Our Ref: Response to RFI

RE: Modification to M2 site, North Ryde Station Urban Activation Precinct (SSD 5093 MOD4) (Lachlan's Line)- Request for Response to Submissions

Figure 1 Location of piers

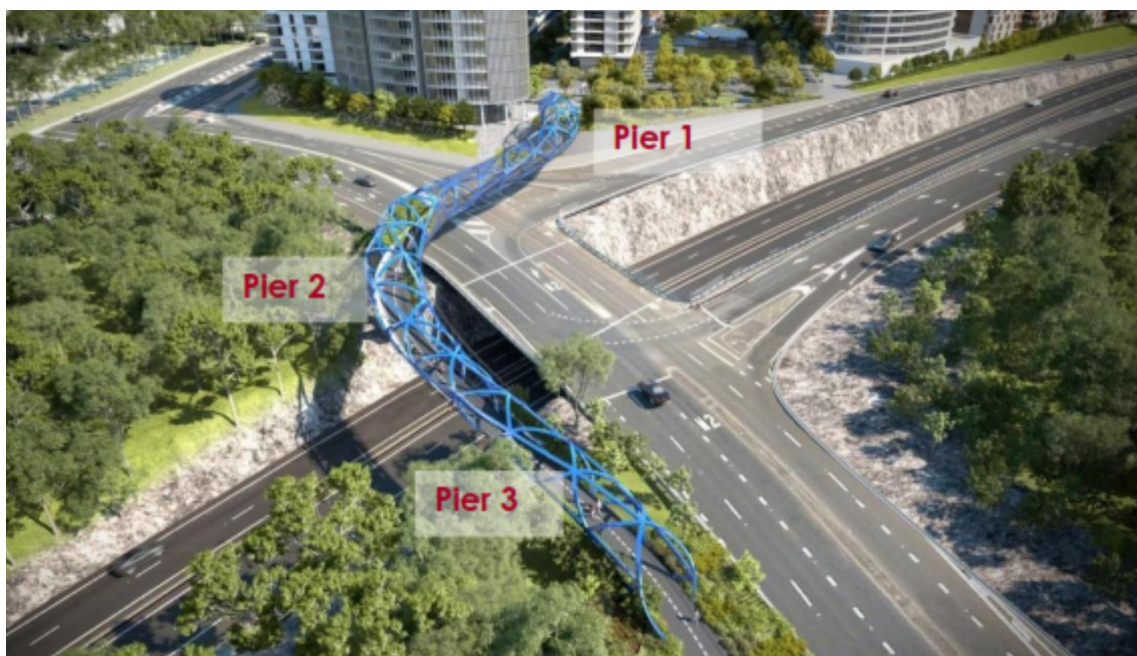
Concurrently, Landcom has consulted with the City of Ryde on the construction approach that will be undertaken for building the piers and piles. With regard to the location of Pier 2, following investigations and consideration of various alternative construction methodologies against a broad set of criteria, Landcom has reached agreement with Council on a preferred option. The agreed approach will see Council grant temporary access to a 21m² area of Bundarra Reserve in the most north-eastern corner. This area will facilitate construction of a level, elevated earth retained platform to provide the necessary piling rig access. This proposal has the least permanent impact to the root zones of adjacent trees in Bundarra Reserve. Minor impacts to Bundarra Reserve have now been reduced to:

- the removal of three small, low significance trees (T36, T37 (dead) and T39) that are not characteristic of Sydney Turpentine-ironbark Forest, and which are also affected by the required RMS 3m maintenance buffer zone

- on-ground compaction impacts of up to 21m² of soil containing Sydney Turpentine-Ironbark Forest seed-bank, and
- up to 25-30m² of canopy overhang impacts from the removal of tree T29 (Blackbutt *Eucalyptus pilularis*) being a tree located within the adjacent RMS road corridor (outside of Bundara Reserve).

The comparison between the impacts from the original scope of works at lodgement to the current proposal is outlined within Table 1. This shows that an additional eight trees will be retained as a result of changes to the construction methodology.
